Amendments

Amendments to the Figures:

tooket No 138-006 Revised sheet 3

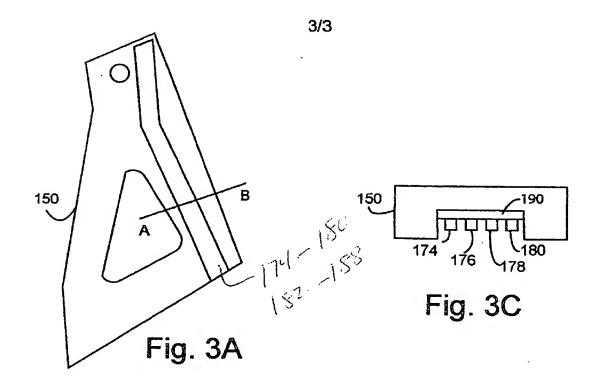
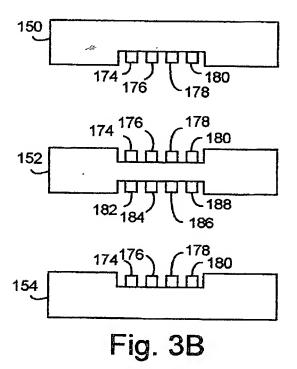
Figure 3A has been amended by red ink to indicate a first and a second pair of coplanor, parallel transmission paths 174-178 essentially parallel to the ground plane. The head arm 150 may further include a first and a second pair of coplanor, parallel transmission paths 174-178 essentially parallel to the ground plane.

Fig. 4A

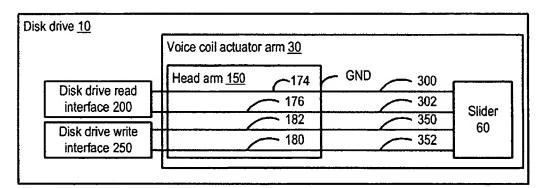
Figures 4A and 4B have been added to illustrate disk drive 10 include voice coil actuator arm 30 including at least one head arm 150 providing at ground plane for a first and a second pair of coplanor, parallel transmission paths 174-178 essentially parallel to the ground plane. The head arm 150 may further include a third and a fourth pair of coplanor, parallel transmission paths 184-188 essentially parallel to the ground plane.
